Town of Lauderdale-By-The-Sea
Regular Planning and Zoning Board

Agenda

Wednesday, September 3, 2025

5.a. Request 1: Site Plan 2023-SP-01 Description: Pursuant to Chapter 30, “Unified Land Development Regulations,” Article IV, “Development Permits –Applications, Requirements and Review Procedures,” Division 2, “Site Plan Procedures and Requirements” of the Town’s Code of Ordinances (the “Town Code”), the Applicant has requested Site Plan approval to demolish an existing 2 story hotel and construct a new 3 Story hotel containing 22 hotel units for property located at 4312 El Mar Drive (the “Property”).

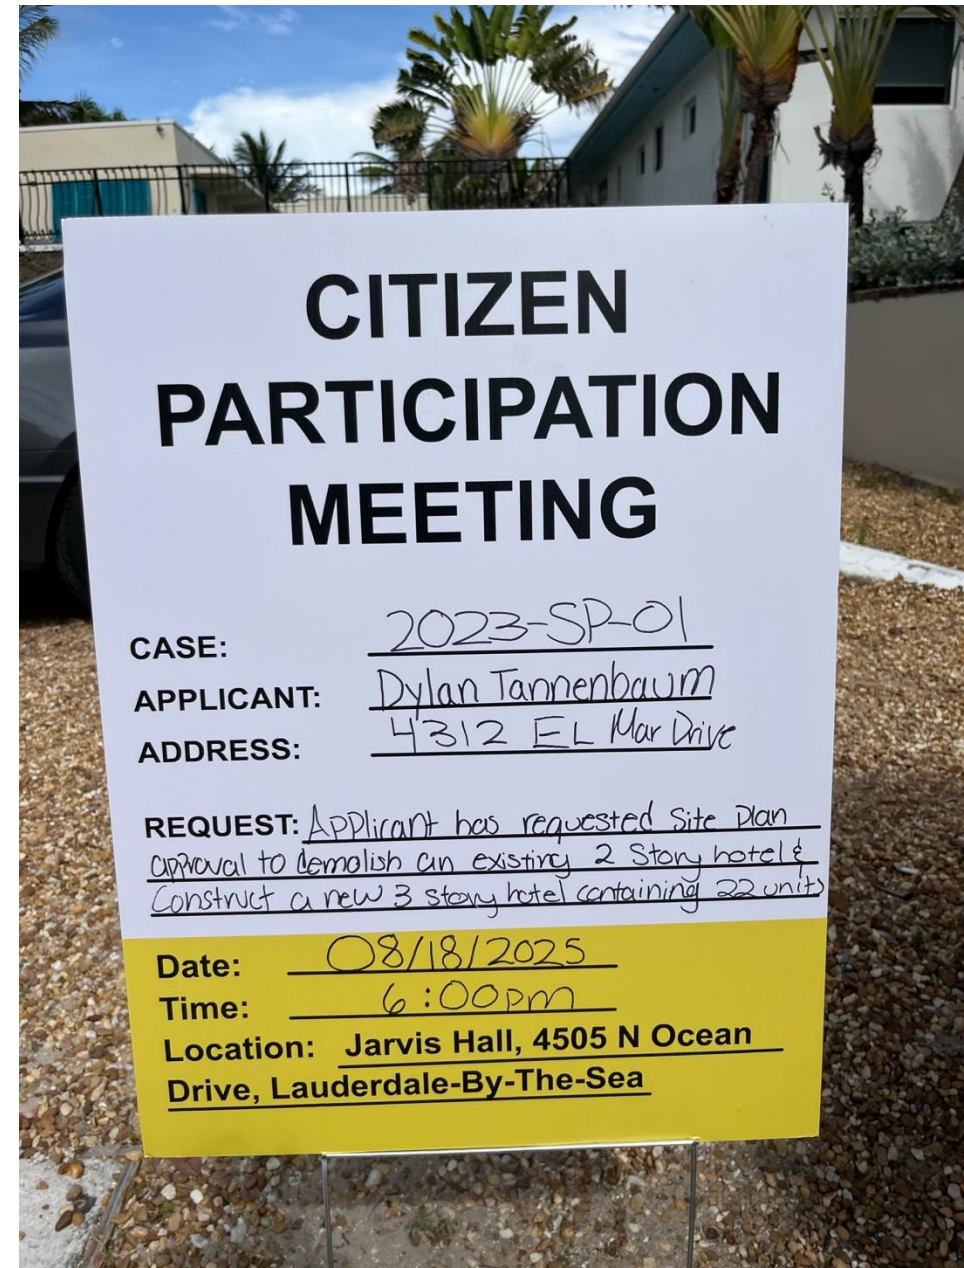
As a result of removing the portion of the balcony that faced North, there is no way to add the slats we used to create privacy on our other balconies. We feel that we have mitigated the issue as much as possible so that our guests do not see freely into the neighboring units at Oriana, and we have consulted with Ms. Locay on the changes we made and she is content with them. We still need the window on the North corner of the property to allow for enough natural light in the unit.

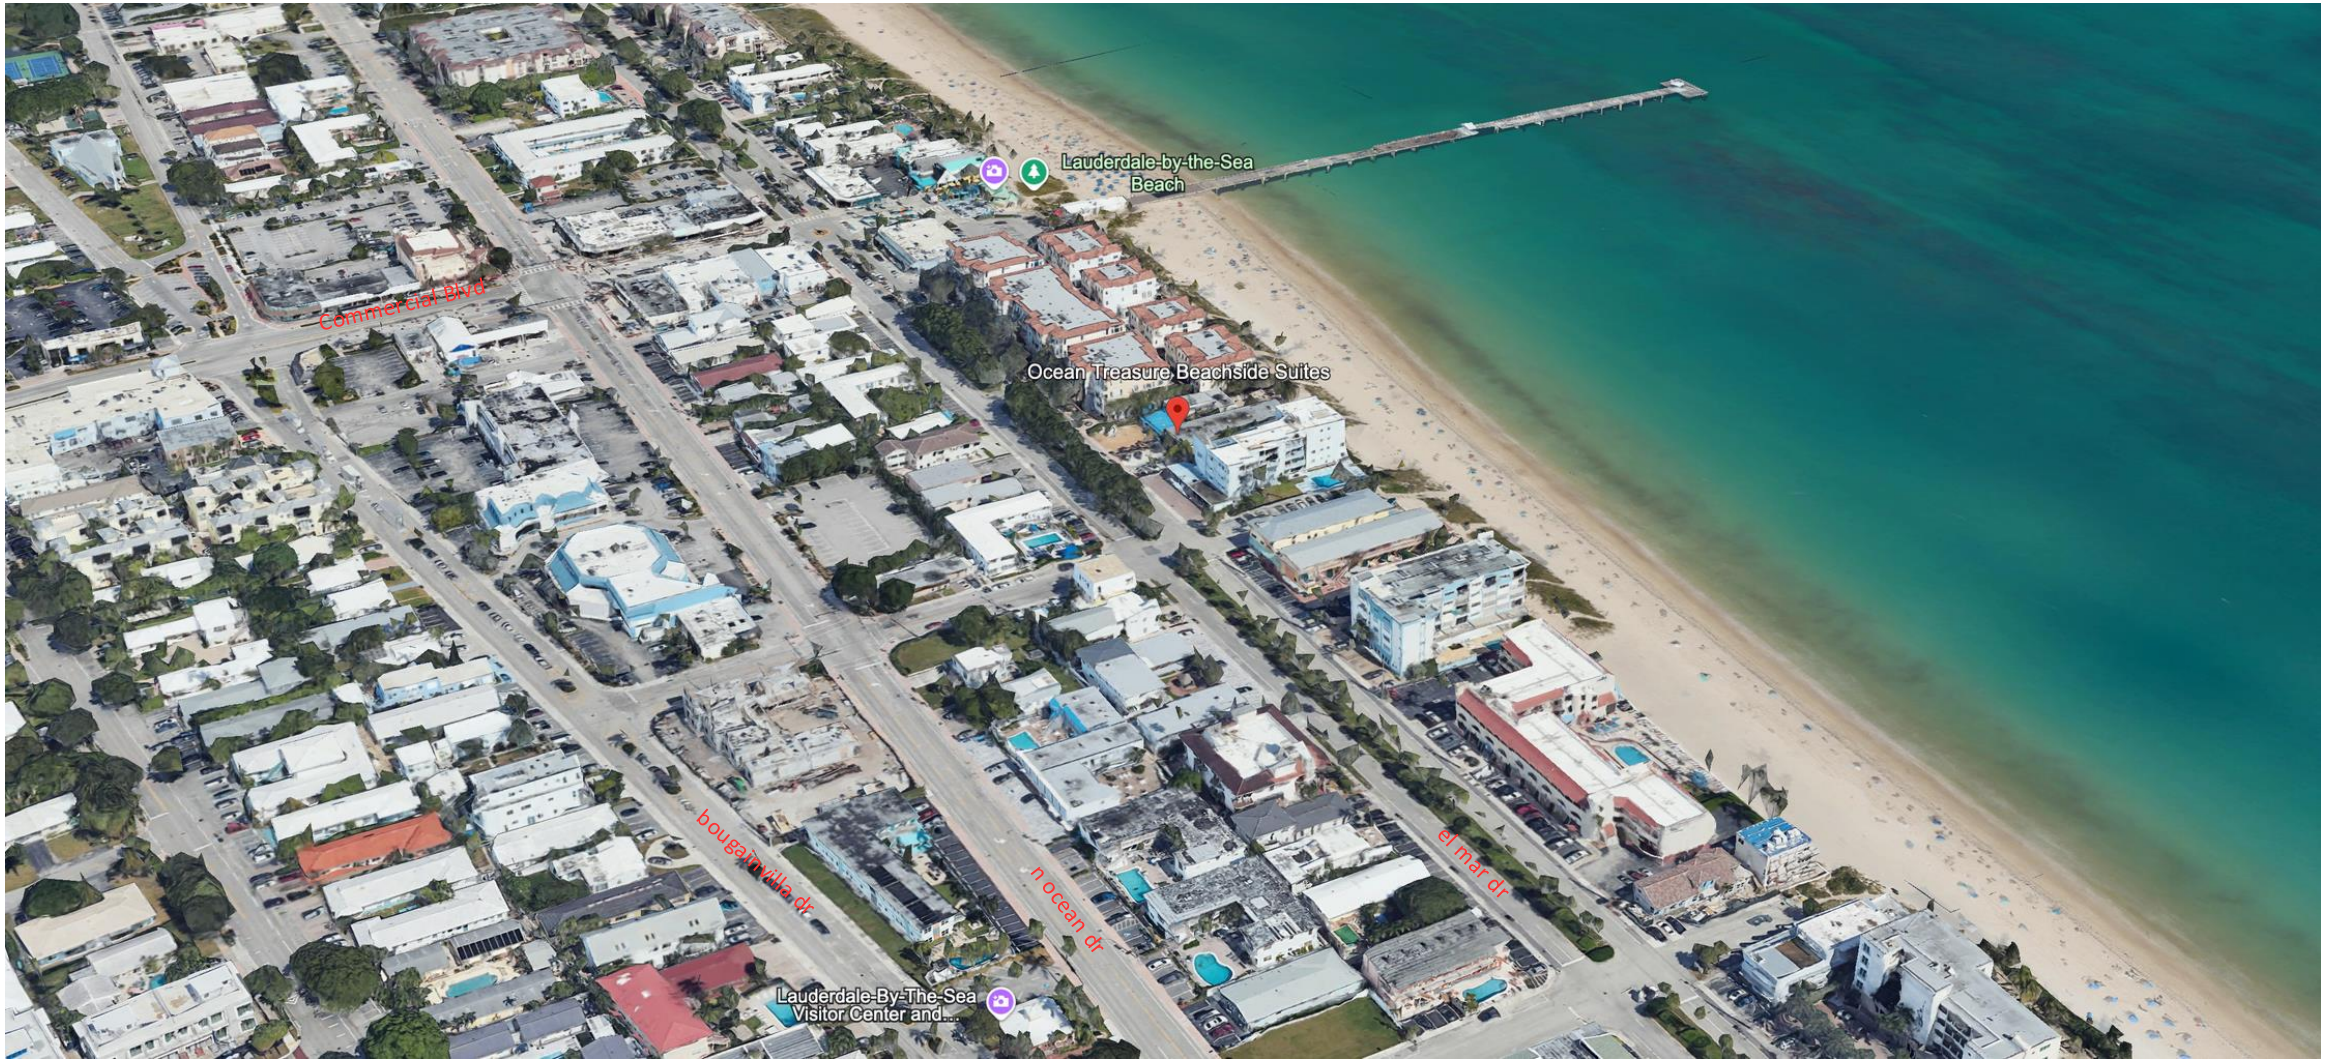
3. Ms. Locay's third issue pertains to the parking along the perimeter of the building. She would like us to have a hedge of some sort to block the car lights so that when they park they do not disturb Oriana residents next door.
